Project Name: AQUAVISTA - Bayside
Client: TRIDEL Corporation
To: TRIDEL Corporation
Attention: Chadi Loza
Fax number: -

Project No.: 8489D
SI No.: E 039
Page No.: 1 of 2+ 5 attached
Office: Toronto
From: Sunanda Perera
Radovan
Andulajevic

Title: Additional EV Charging Stations.

Project
Hines TRIDEL
AQUAVISTA
Block 3 - R3 & R4
Queen's Quay East
Toronto, Ont
As Indicated
Author
Checked By
Checker
S489D
08/28/12
Date
Drawing No.
E1-01

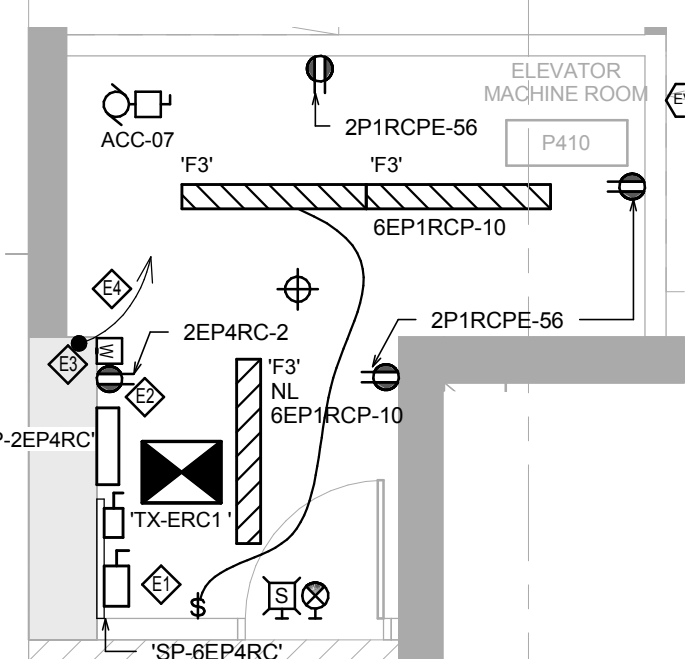
Drawing No.	Drawing Issued	Items
Electrical drawings have been revised to address the EV charging replacement from Type-1 to Type-2		
E1-01, E1-02	Yes	- Replace type-1 charging stations with type-2 (Total Qty-5). - Feeders and conduits to be added for this change.
E3-01-RC	Yes	- Add new service panel, transformer, breakers, and wiring necessary for the conversion of parking units as shown. - Coordinate with metering contractor for required metering addition.
E5-01	Yes	- Add new panel 2P1RC1-EV and transformer 'TX-RCE6' as shown. - Locate the panel '2P1RC1-EV' maintaining the working clearance in front of the panel. Update the exact location in as built drawings.
